EL DORADO RURAL PUBLIC WATER AUTHORITY
PARNELL ROAD SEWER FORCE MAIN EXTENSION AND
VALVES FOR MASTER METERS
ARKANSAS NATURAL RESOURCES COMMISSION
PROJECT NO. 23-203

AUGUST 2024
REV. JUNE 2025
ADDENDUM I - 15 JULY 2025

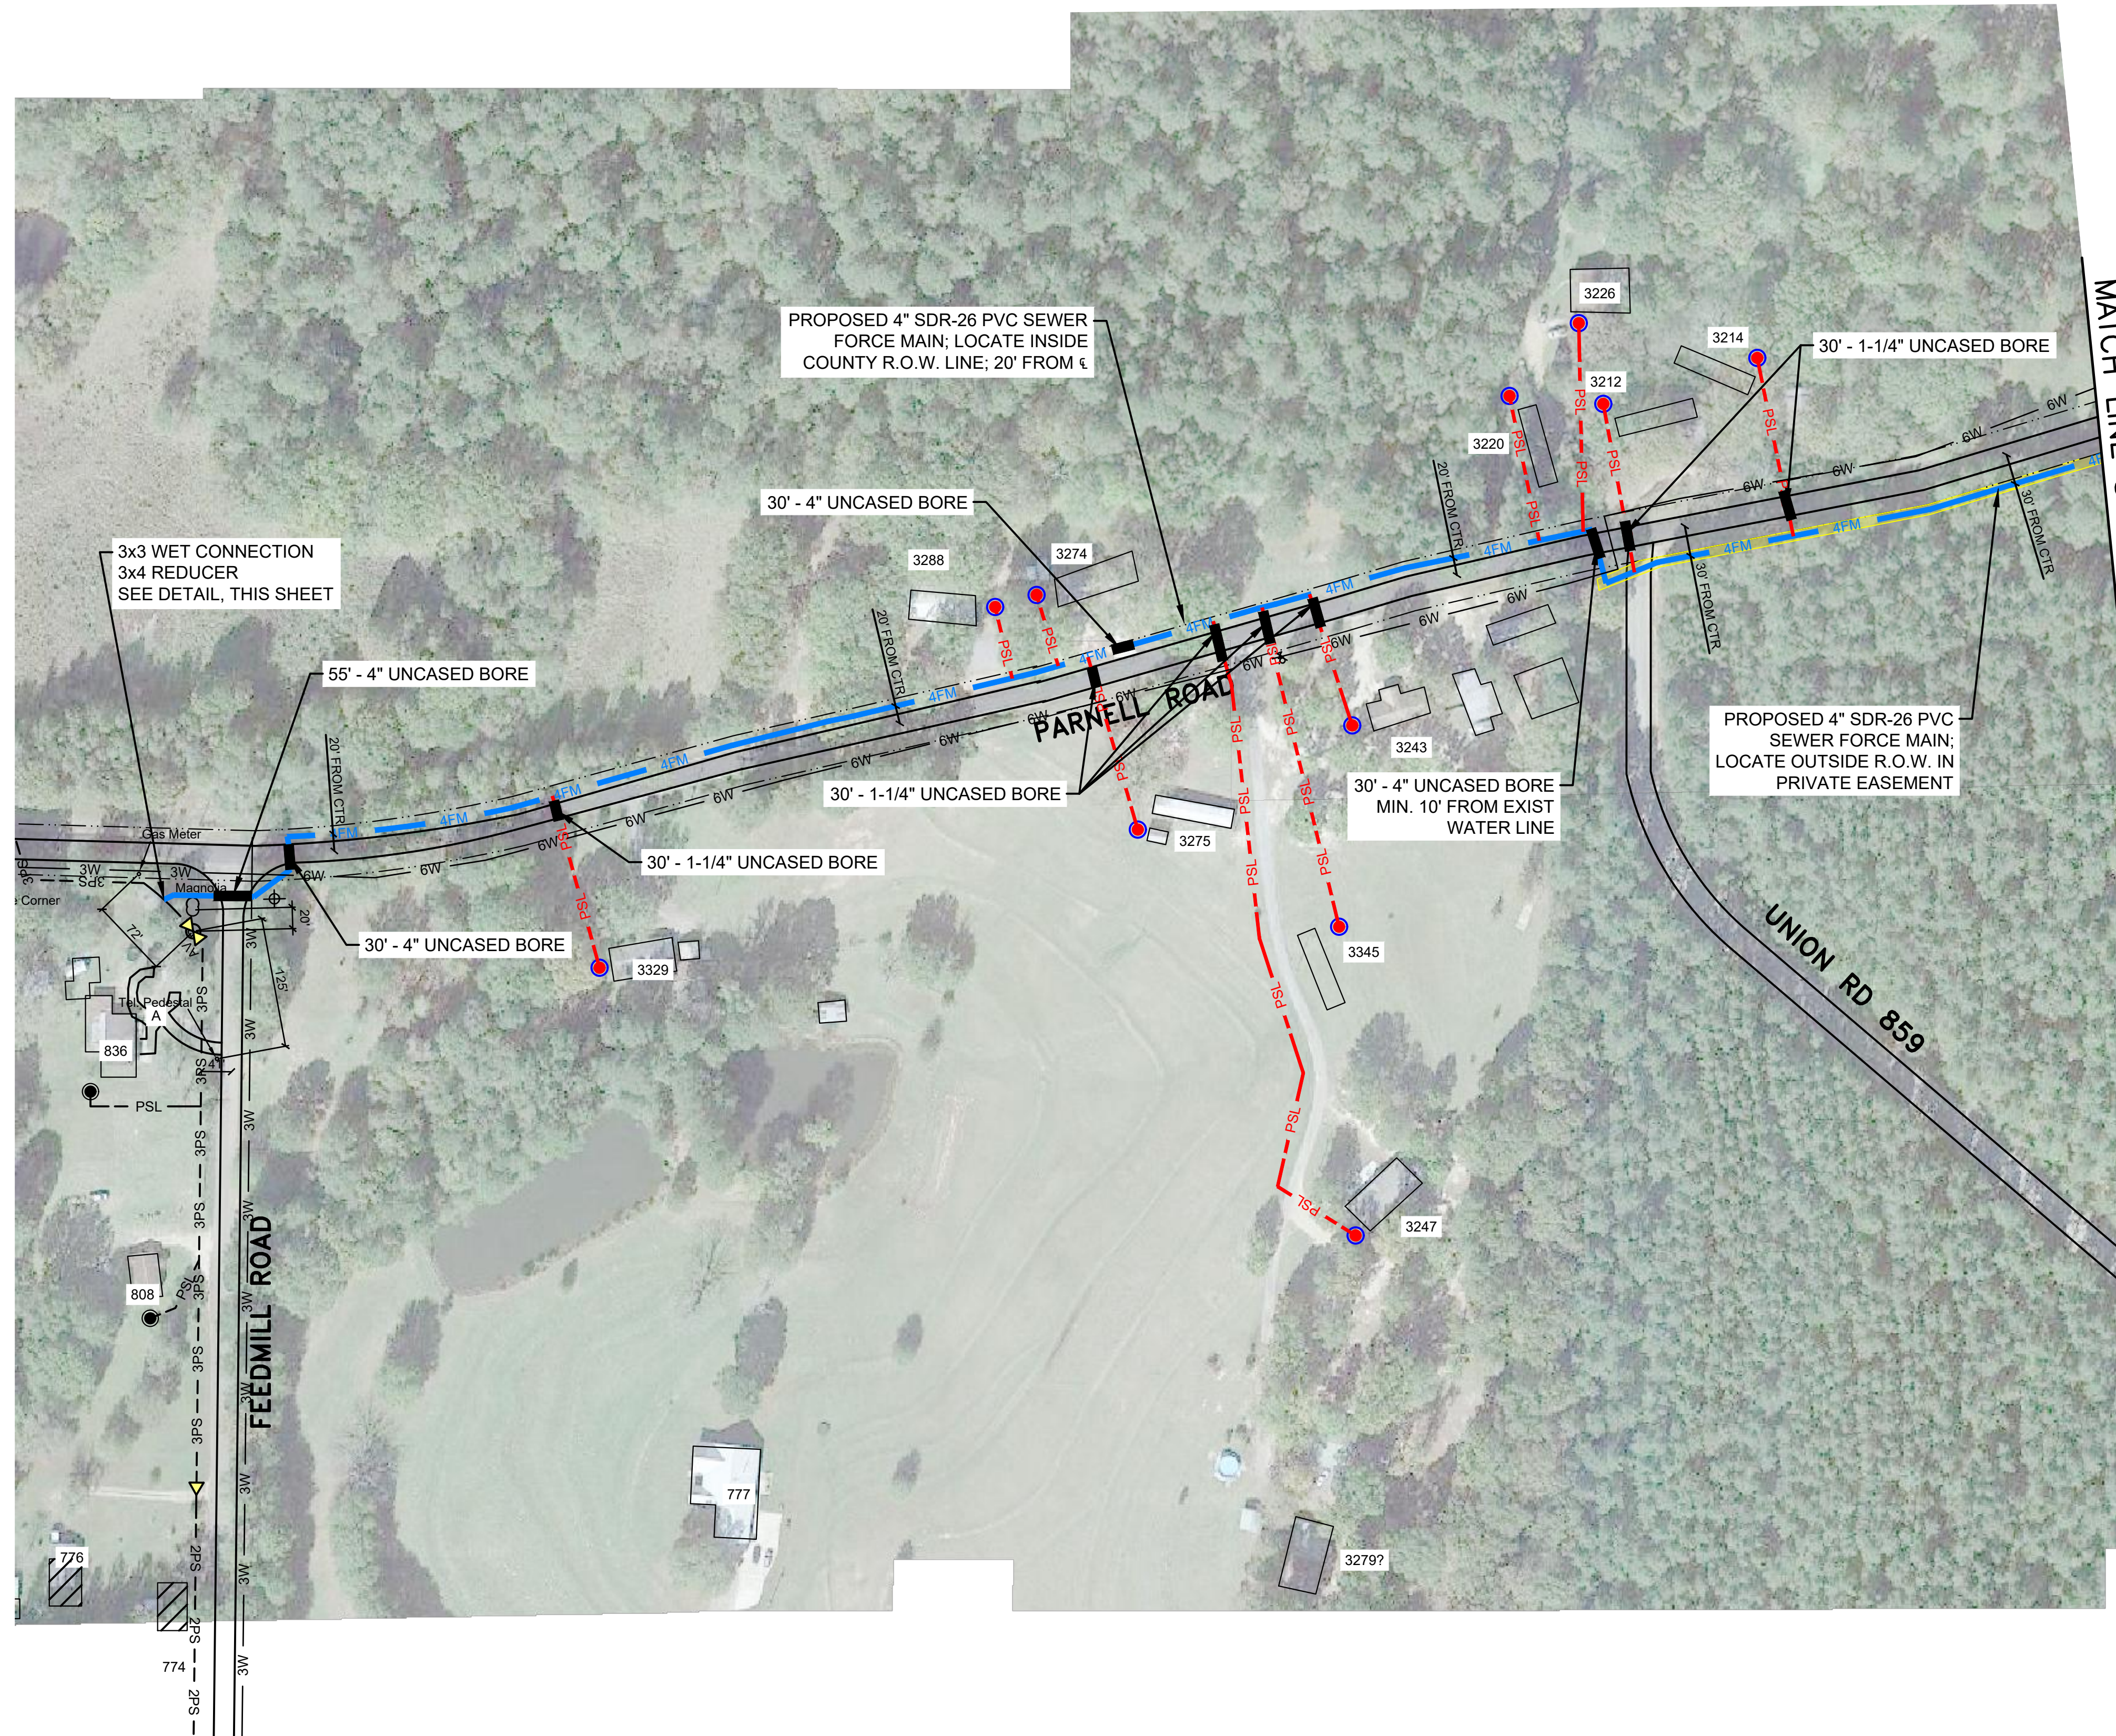
A-1		ADDENDUM 1 - REVISE DESC. OF EXIST VALVE	07-2025			DESIGNED BY		CHECKED BY	
		MOVE PORTION OF LINE TO PRIVATE EASEMENT	06-2025			DRAWN BY	JKD	APPROVED BY	
		MOVE LINE INSIDE R.O.W.	02-2025			PLOT AT 1:	2.12	DATE:	
REV.		DESCRIPTION	CHK.	DATE	APP.	DATE	SCALE	DRAWING NUMBER	REV.
							1"=100'	2

**EL DORADO RURAL PUBLIC
WATER AUTHORITY
BYPASS LINES AROUND
MASTER METERS**

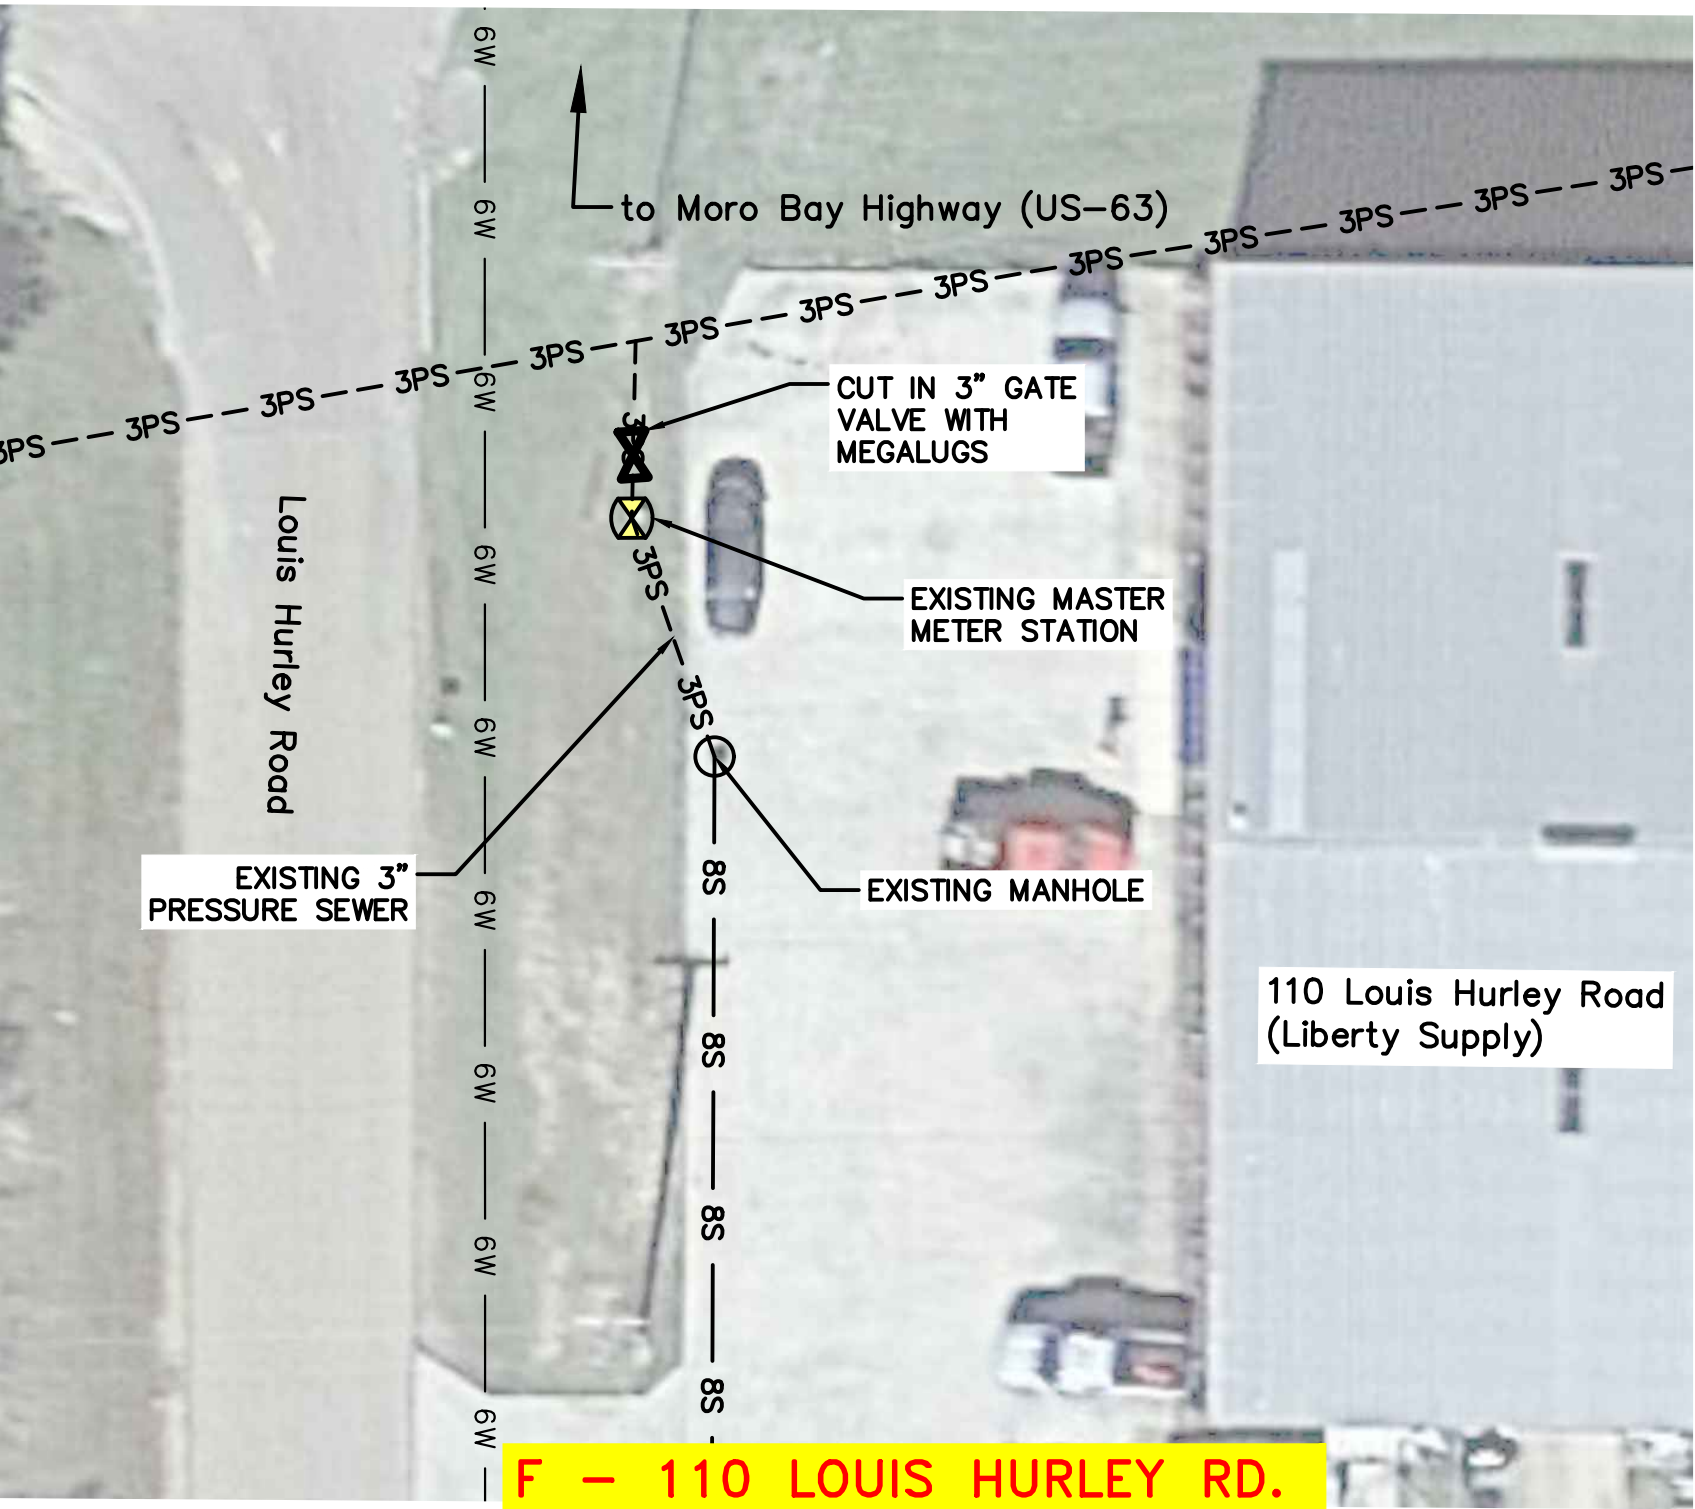
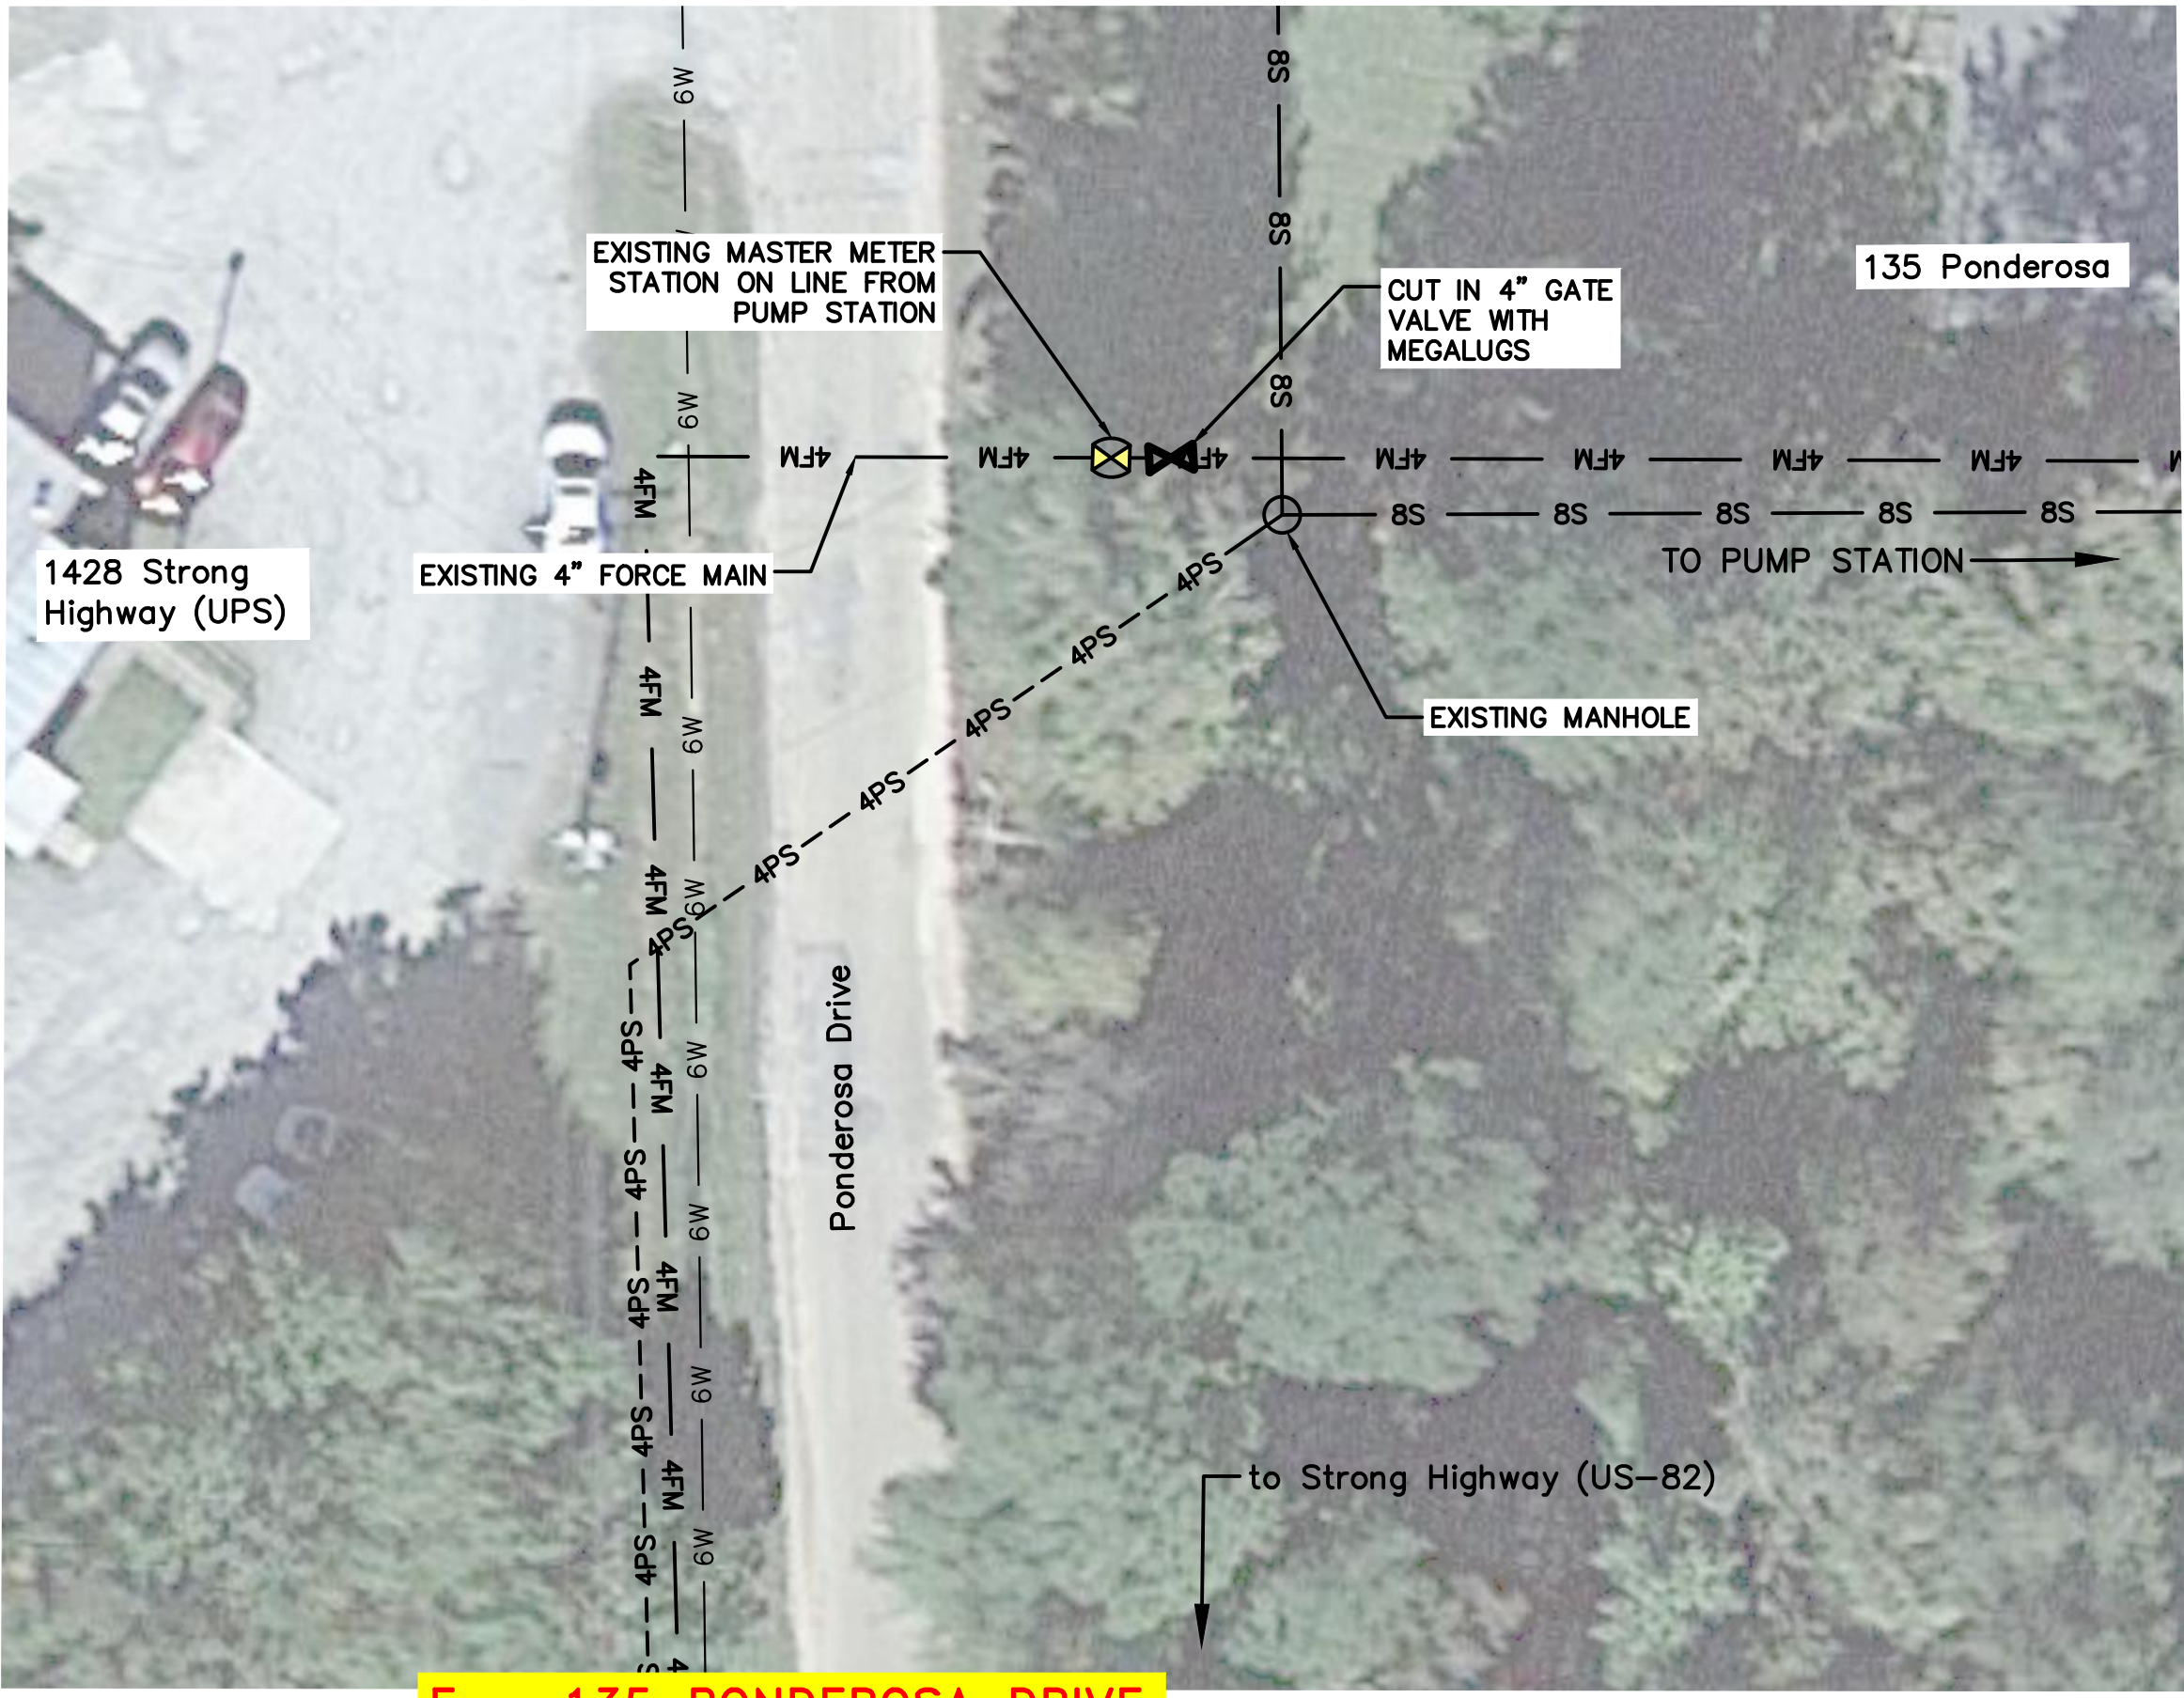
REV.	CORRECTED LINE SIZE IN CALLOUT	DESCRIPTION	CHK.	DATE	APP.	DATE
